BOARD ACTION REPORT – APPEALABLE ITEM

Project Name: Auto Zone Delray
Project Location: 220 North Federal Highway
Request: Class V Site Plan, Landscape Plan, Architectural Elevations, and a waiver request.

Board: Site Plan Review and Appearance Board
Meeting Date: April 13, 2016

MEETING DATE: April 13, 2016
ITEM: Auto Zone Delray (2015-166) – Class V Site Plan, Landscape Plan, Architectural Elevations and Waiver request for the construction of a one-story retail building and associated site improvements on the property located at 2200 North Federal Highway.
RECOMMENDATION: Approve subject to conditions.

FRONT WALL
(East View)

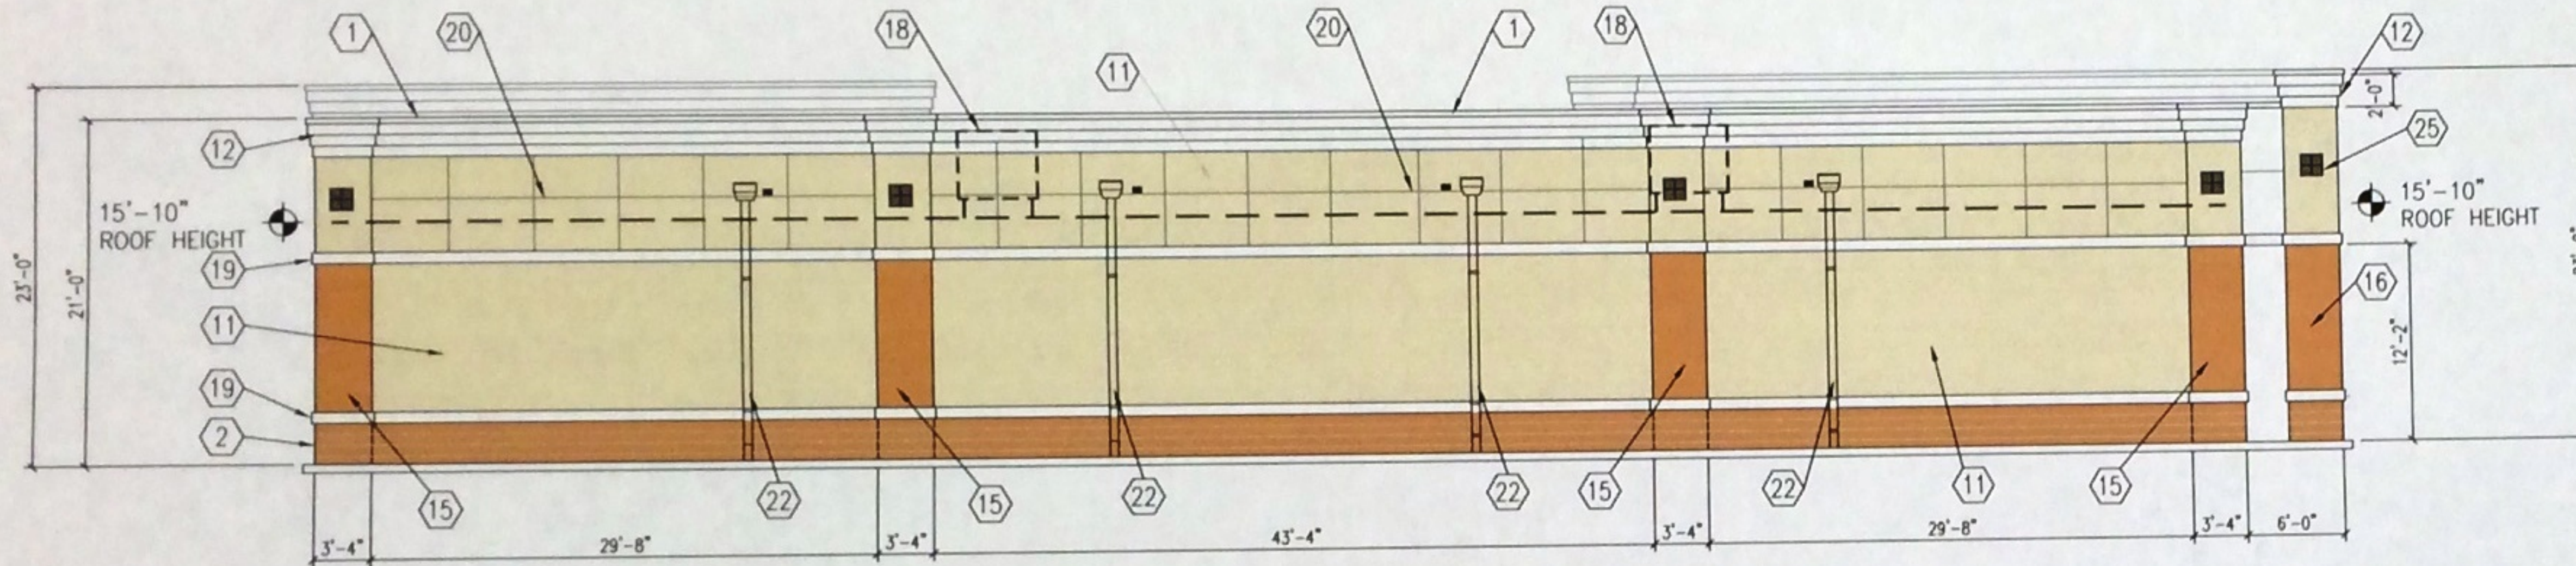
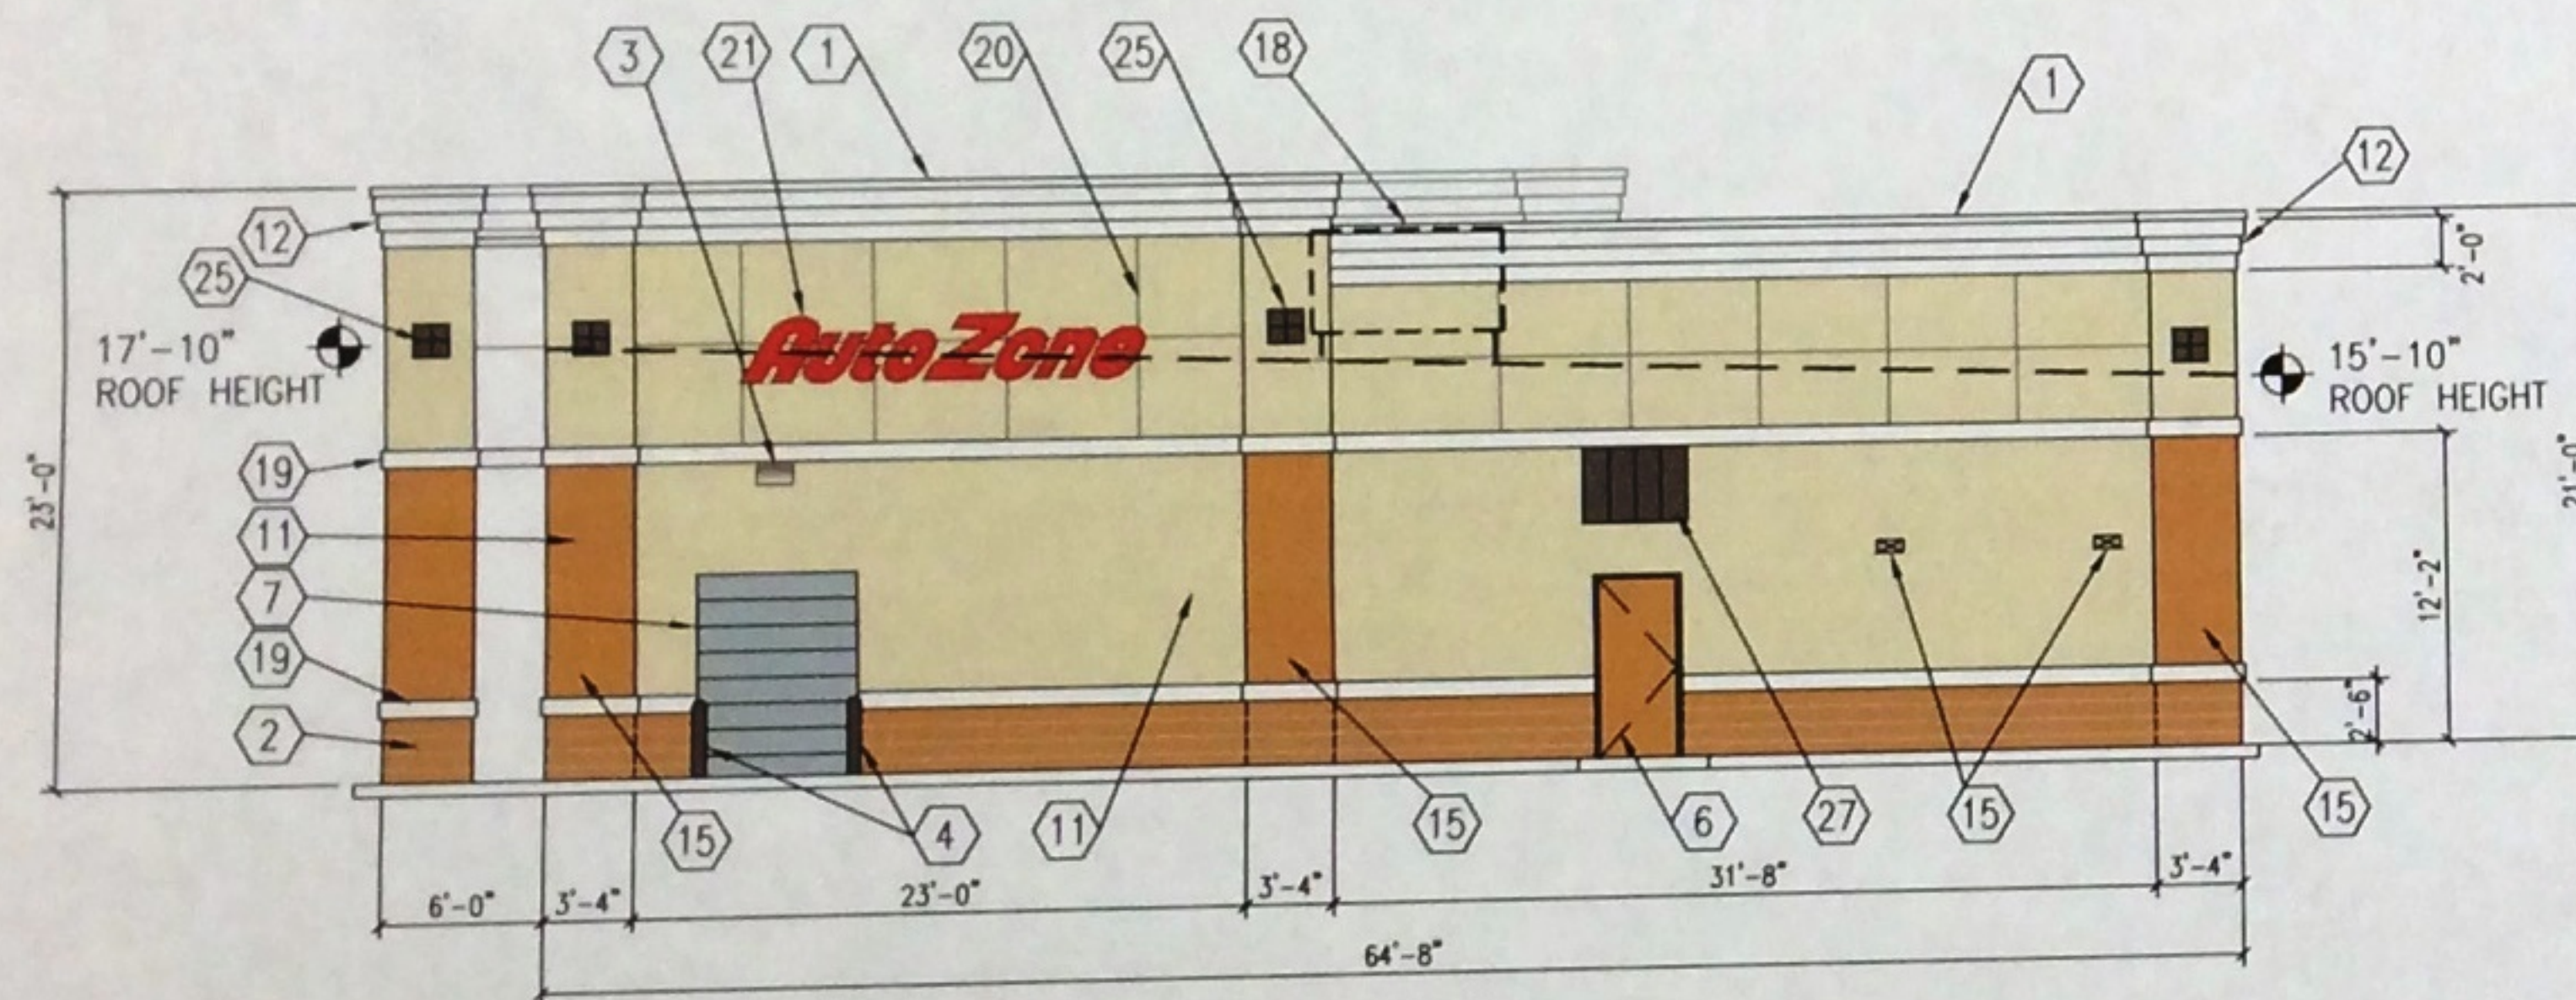
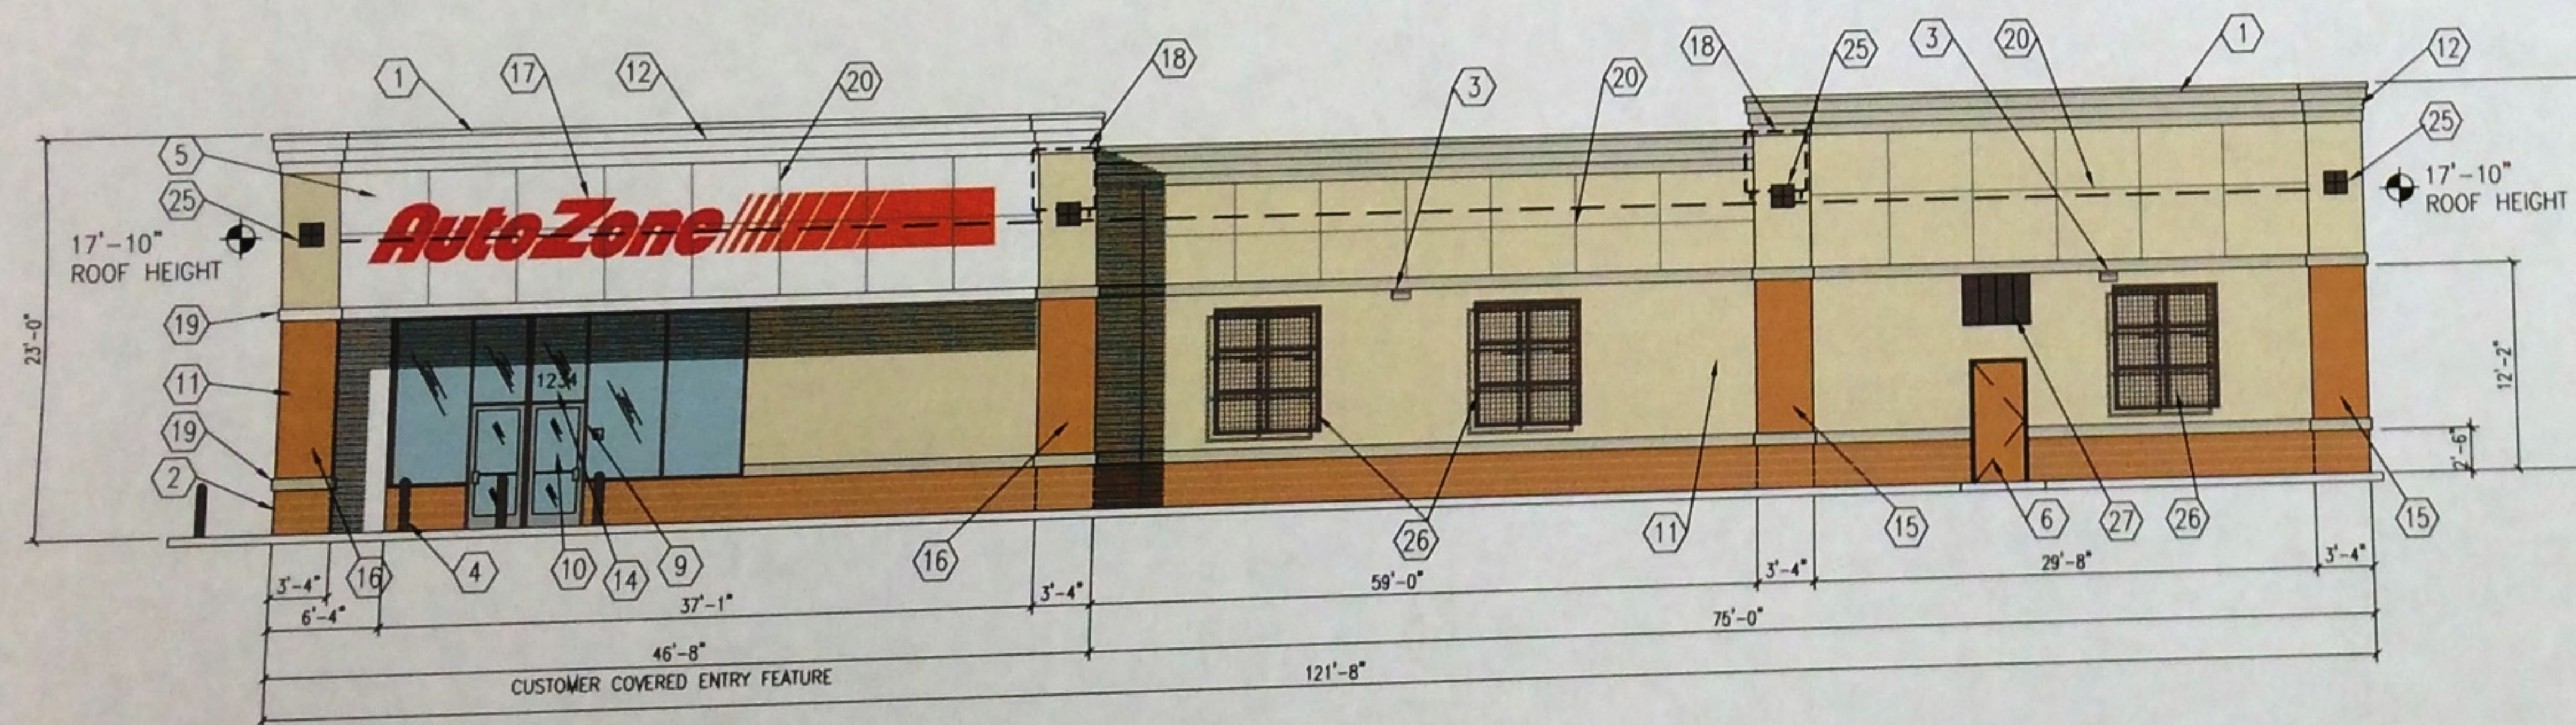
It is noted that the signage has been included on the elevations, but should be removed prior to plan certification so as to not be misconstrued as approval for the signage. Signage review is required to be applied for, reviewed, and approved separately.
